Computer Monitors Service Bulletin

Model: GDM17SE1 No. 70

Subject: Countermeasure for dimming picture **Date:** November 18, 1994

Symptom:

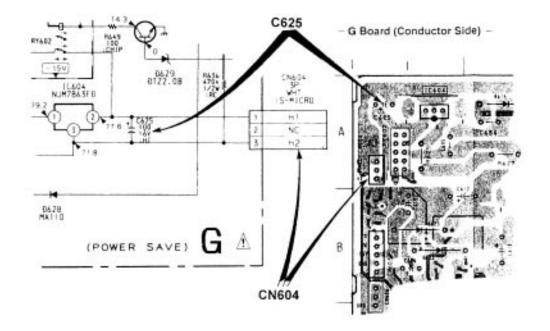
(332) After a while, the picture dims and eventually disappears completely

Solution: Do not replace the Picture tube nor the Power Supply board (G-Board). Instead please check C-625 first.

C-625 is located on the G-board and it is the main filter for the CRT heater voltage. In some rare cases visual inspection will reveal an inward indentation on the top of the capacitor. This indentation causes the heater voltage across the CRT to drop due to cap failure. Replace the Capacitor.

If this is not the case, check the heater circuit for normal operation. CRT confirmation may be done by disconnecting CN604 (heater voltage) and applying an external regulated 6 volts DC directly to H1 and H2 on the A-Board.
